II. RESPONSES TO DEIS COMMENTS
DEIS Sec. I · Executive Summary

COMMENT NUMBER	COMMENT/RESPONSE
<u>SITE LAYOUT AND BUILDING DESIGN</u>	
2203	The Board also voted to request that a greater attempt be made to make the buildings look like an authentic part of Sleepy Hollow rather than a series of mall-like structures with fake facades hung from them.
3406	Aesthetically, I applaud Roseland's interest in making the project look consistent with existing architecture in the area. However, I have to agree with comments at the public hearings that the proposed rooflines were insufficiently varied. The overall appearance was akin to a suburban sprawl mall, compromising the desirability of the units.
4302	2. The Village Board is generally satisfied with the design concept and treatment for Beekman Place, although the Applicant will need to identify how loading and refuse removal would be accommodated. However, the interior residential blocks have not yet received the same level of detail and basically represent potential building templates. Additional analysis regarding scale, massing, and place-making for the multi-family residential buildings is necessary, including the precedent examples o

FEIS FIGURE NO. II-7

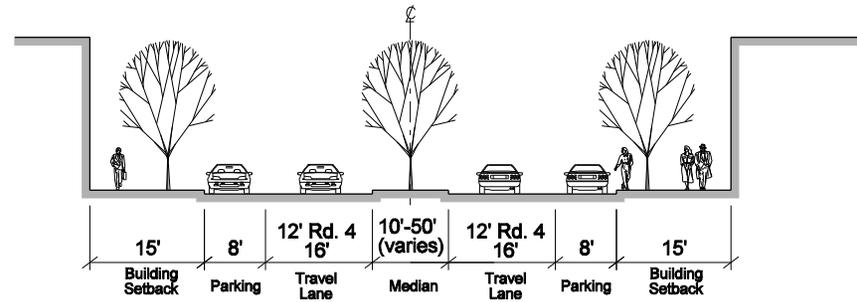
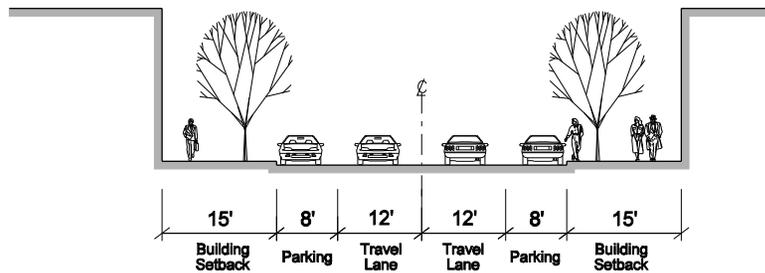
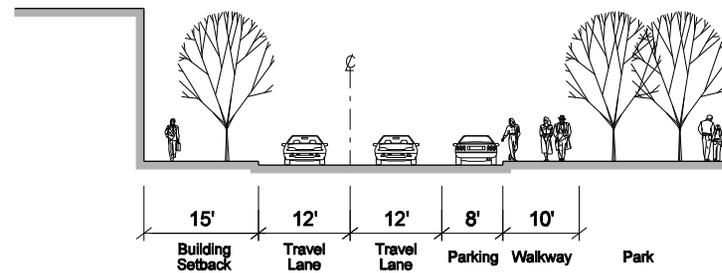
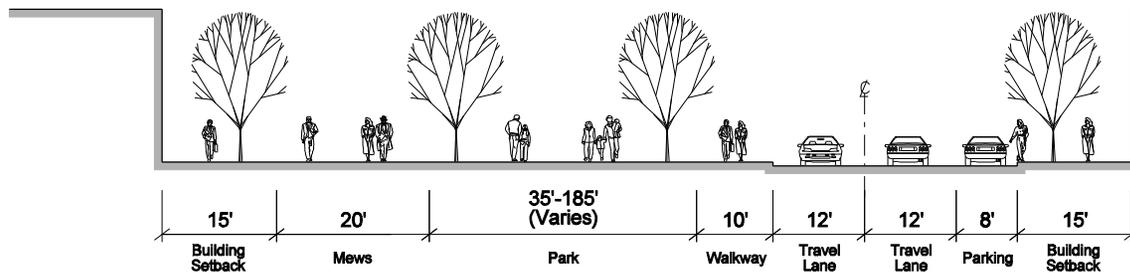
The Beekman Place travel lanes were shown in the DEIS Plan to be 14 feet wide to provide more maneuvering space for stopping or parking vehicles along the main retail street. Under the FEIS Alternative Plan, the Beekman Place lanes have been reduced to 12 feet in width, consistent with the majority of the other site roadways. See FEIS Figure No. II-8, Typical Roadway Cross-Sections.

Riprap Embankment

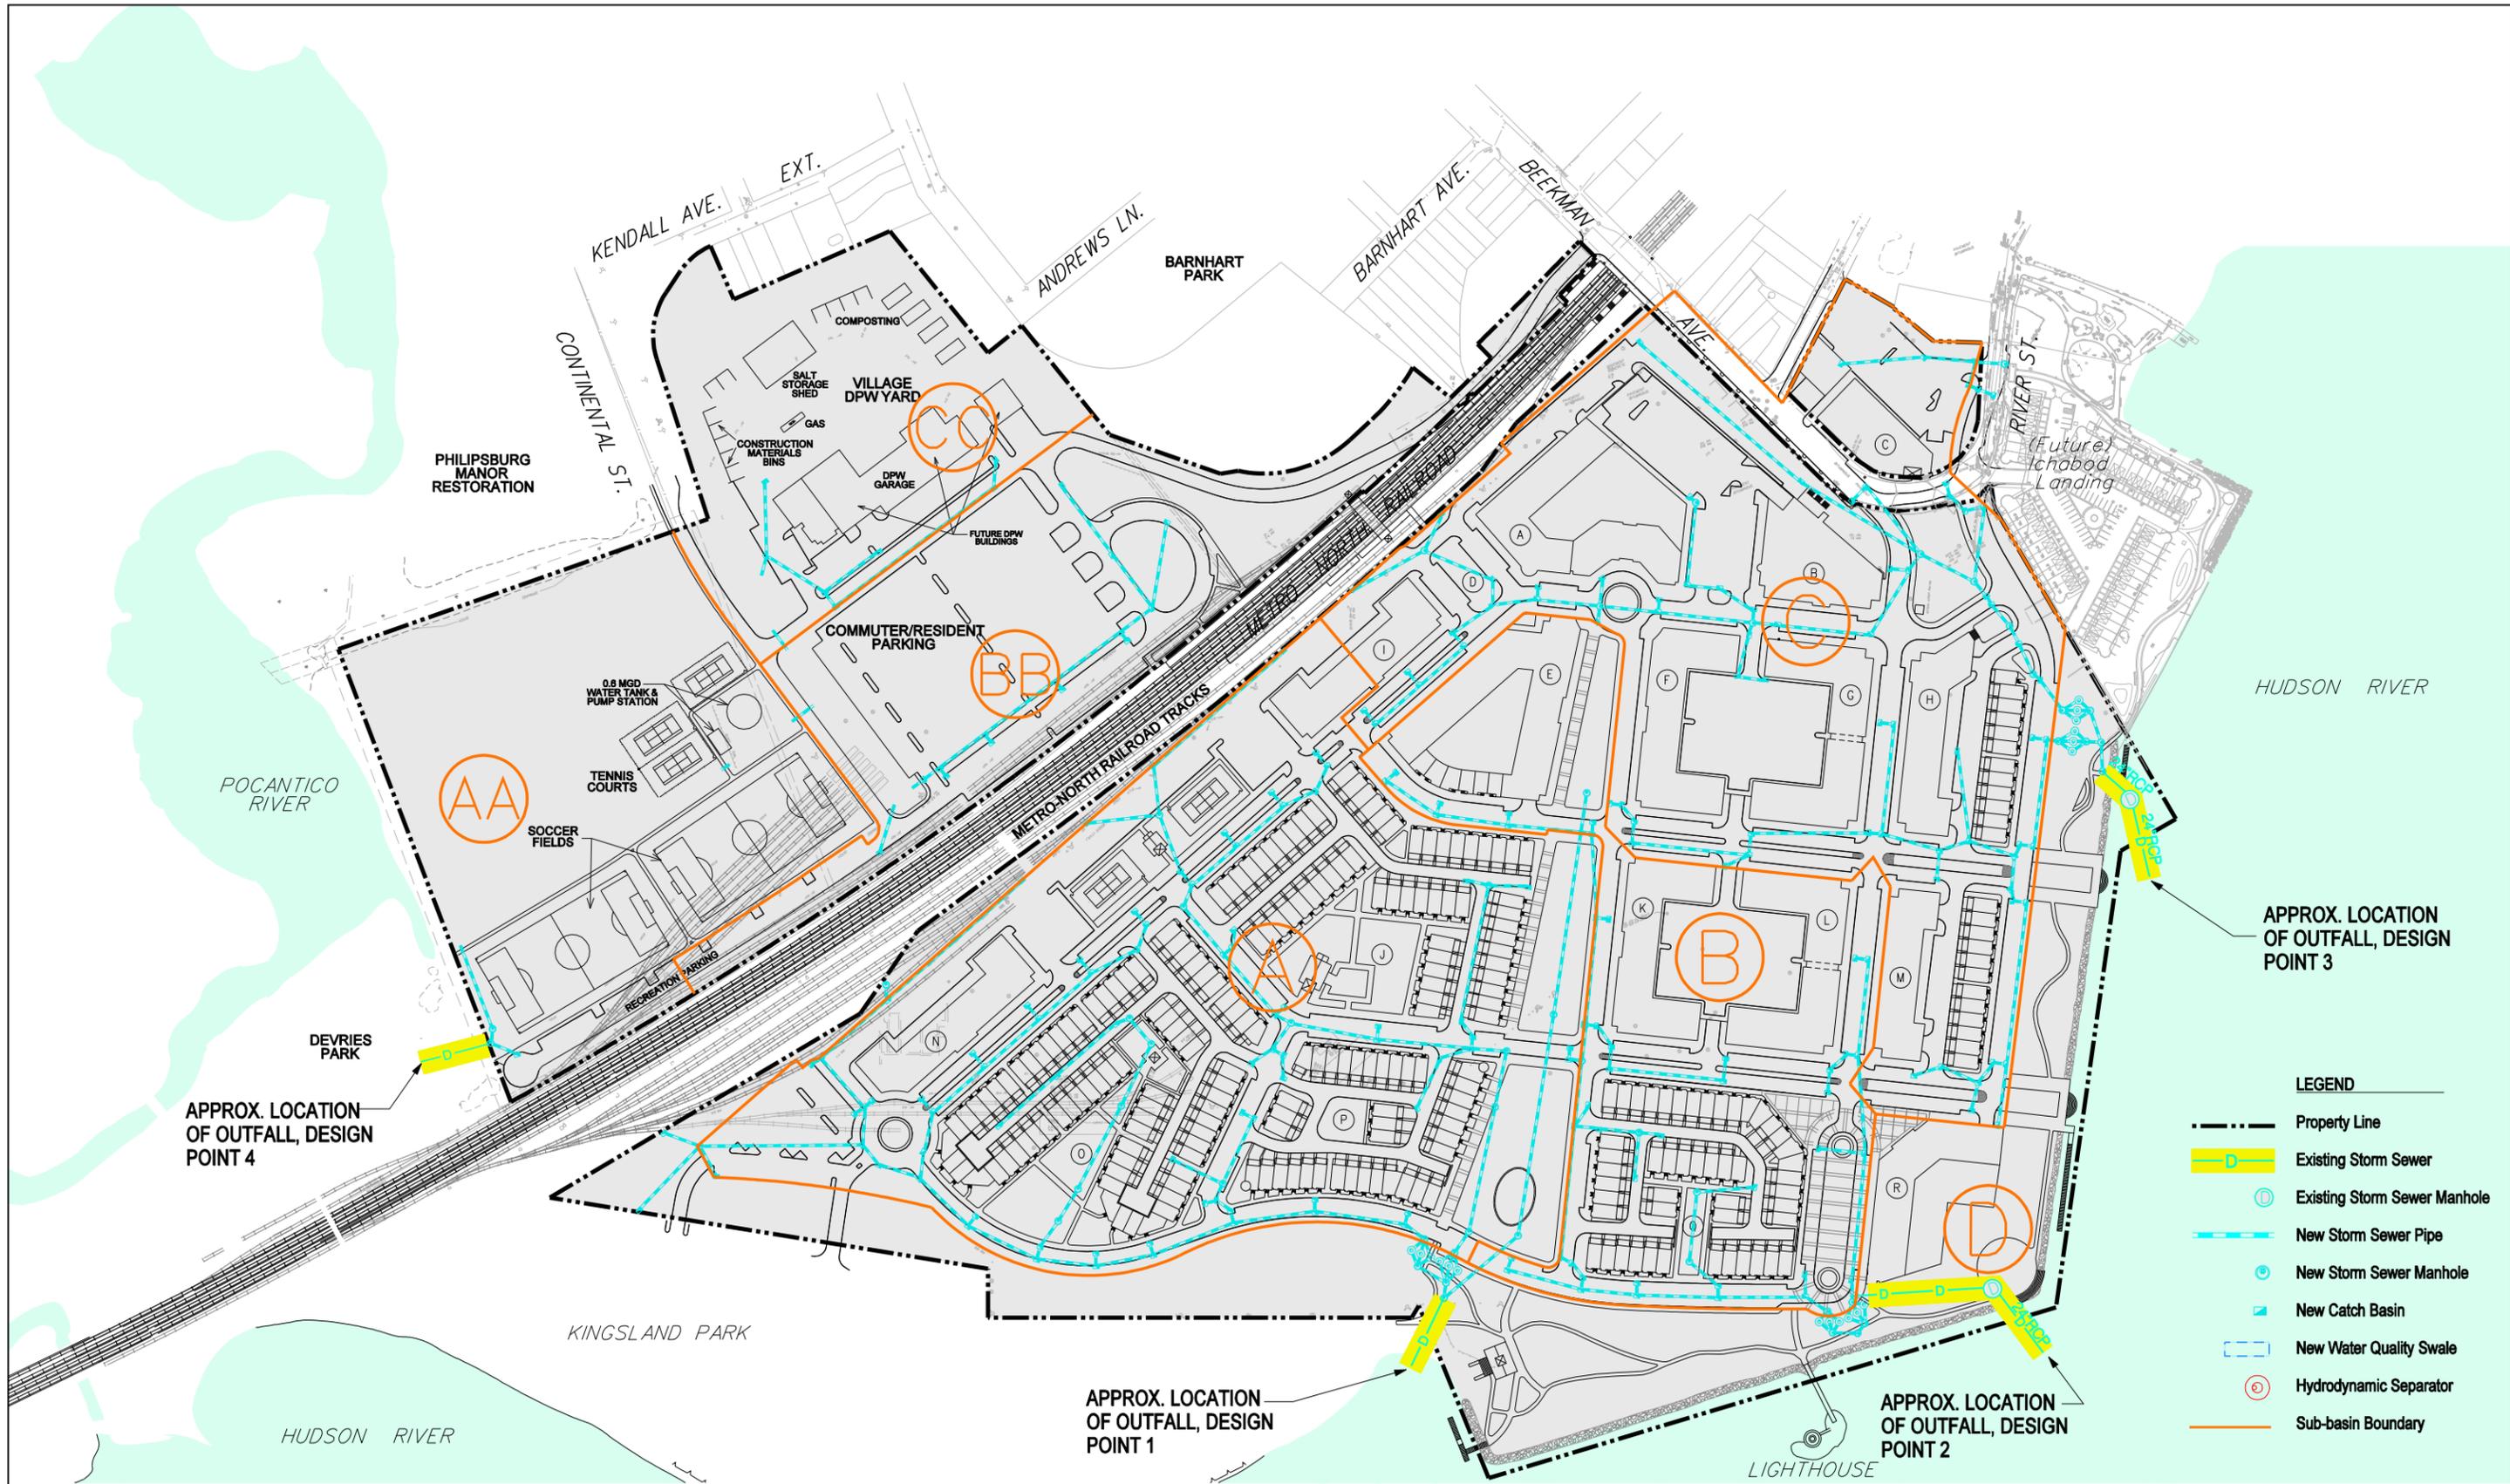
The gradation of stone used to create the embankment along the western frontage south of the lighthouse as well as adjacent to the North Channel (Reach C) of Tarrytown Harbor is poor with stones in the tidal zone susceptible to shifting under wave, current and/or ice loadings, as is evident by the shifting of several stones while inspector walked the slope and by visual observation. The riprap embankment in this area appears to be at a 1:1 slope. For a 1:1 riprap slope to be stable in aquatic environment, a properly placed riprap embankment would have a complementing gradation of appreciably-sized stones to fill the voids between the larger stones and prevent shifting, a process called chinking, essentially to wedge/block stones together. These frontages are not well-chinked, at a minimum in and above the tidal zone, and as a result we content that localized shifting of stones is occurring, resulting in localized top of slope failures (see attached photo). In addition, a safety issue would exist if this are were opened to public use.

VILLAGE OF SLEEPY HOLLOW
 Lighthouse Landing Site Plan

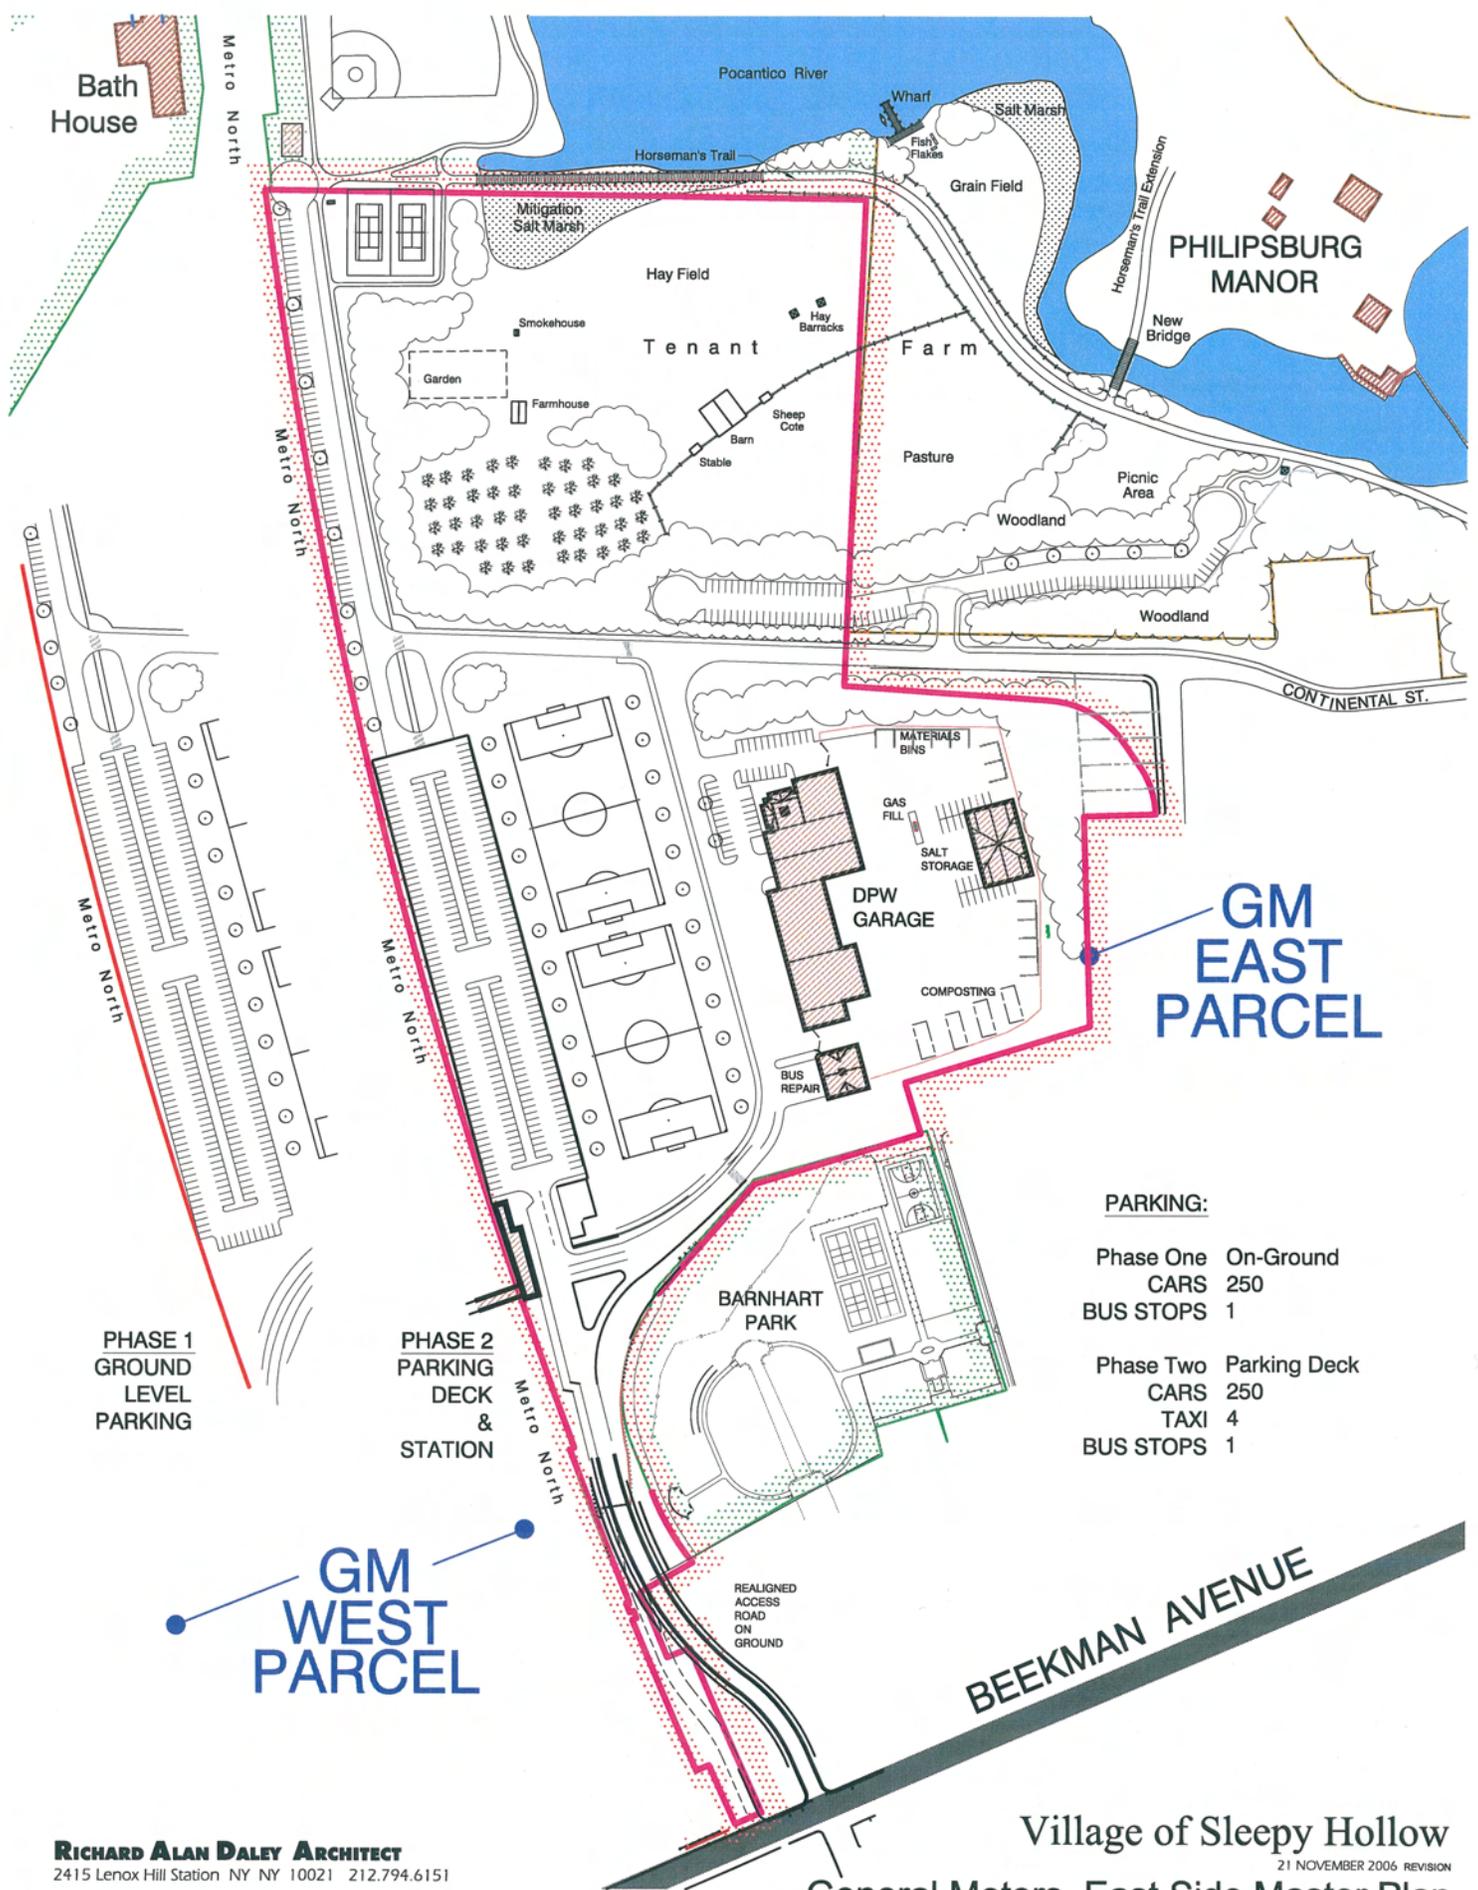
Hide "alley-view" from park.

Replace rip-rap with bulkhead at hotel plaza.
